Invention: OXYGEN-FUEL BURNER WITH
INTEGRAL STAGED OXYGEN
SUPPLY

Serial No: 08/954,291

Application to Reissue
U.S. Patent No. 5,458,483
Issued October 17, 1995
on U.S. Application Serial No. 163,424
Filed December 8, 1993

PROPOSED AMENDMENTS TO THE DRAWINGS
UNDER 37 C.F.R. § 1.121(b) (3)

FIG. 3A

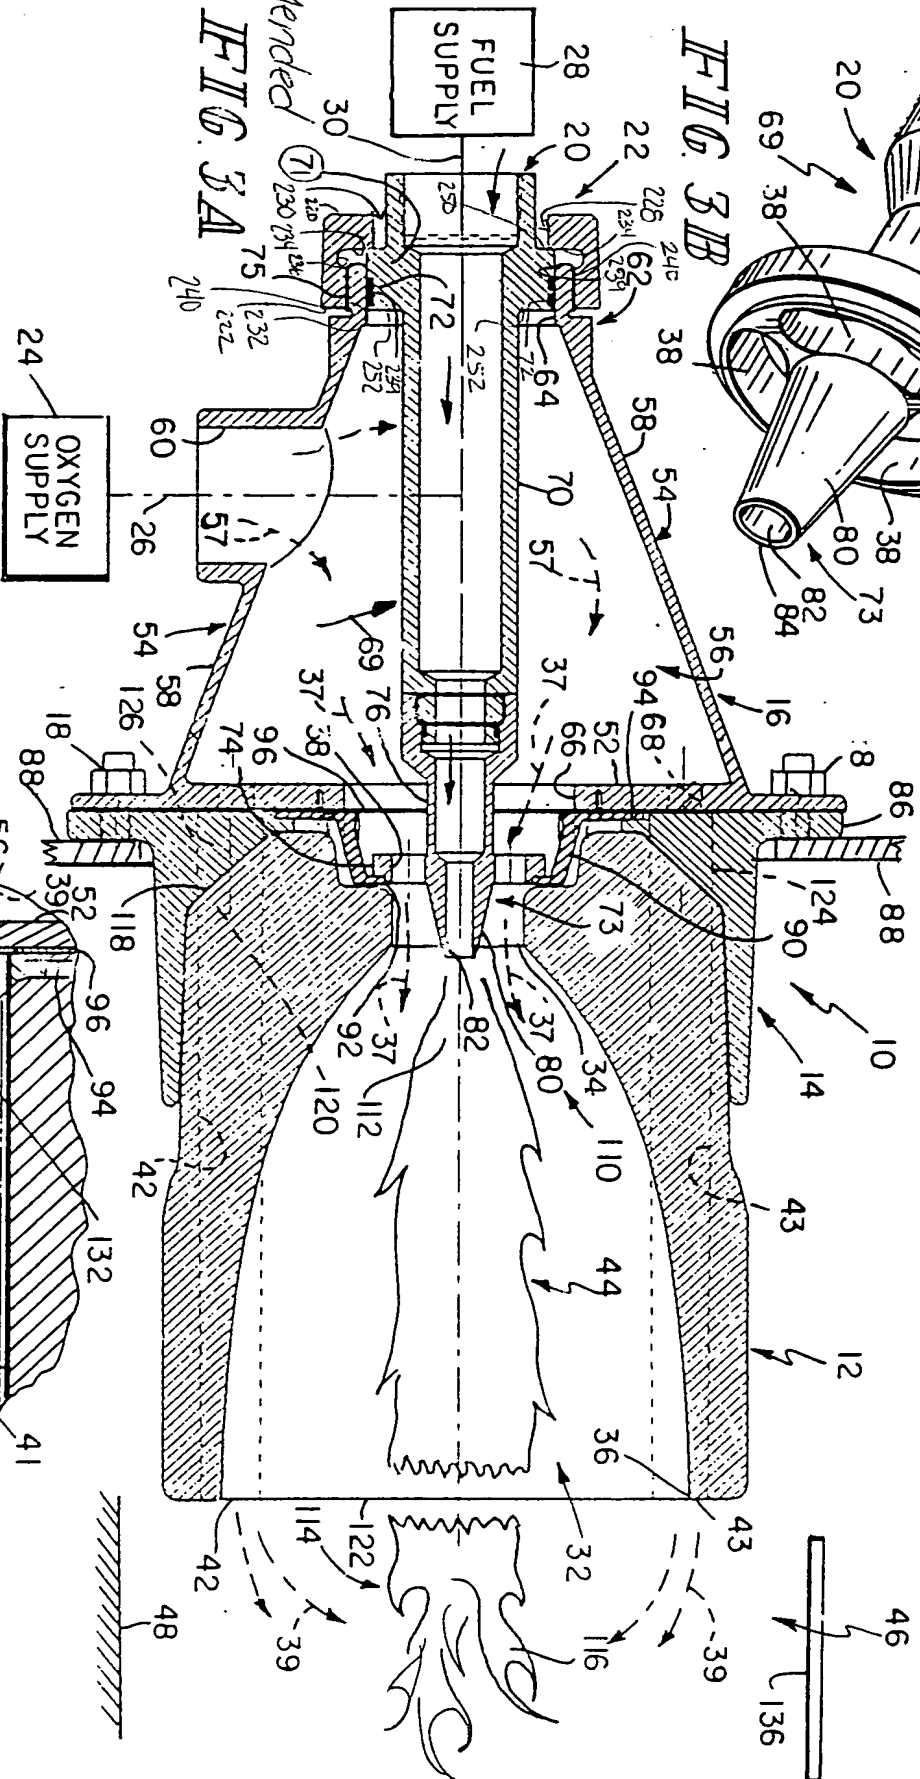
Please amend Fig. 3A of the drawings to change reference numeral 7 referring to a mounting fixture of gas conduit 70 to reference numeral 71. In addition, please amend Fig. 3A of the drawings to include reference numeral 72 referring to O-ring seals; reference numeral 220 referring to an outer surface of removable collar 22; reference numeral 222 referring to an inner surface of removable collar 22; reference numeral 228 referring to an internal side wall of removable collar 22; reference numeral 230 referring to a passageway between outer and inner surfaces 220, 222; reference numeral 232 referring to a threaded portion of internal side wall 228; reference numerals 234 referring to limit tab of internal side wall 228; reference numeral 236 referring to a recess in internal side wall 228; reference numerals 239 referring to an inner surface of rear lip portion 75; reference numerals 240 referring to an outer surface of rear lip portion 75; reference numeral 250 referring to an outer end of mounting fixture 71; and reference numerals 252 referring to an inner end of mounting fixture 71.
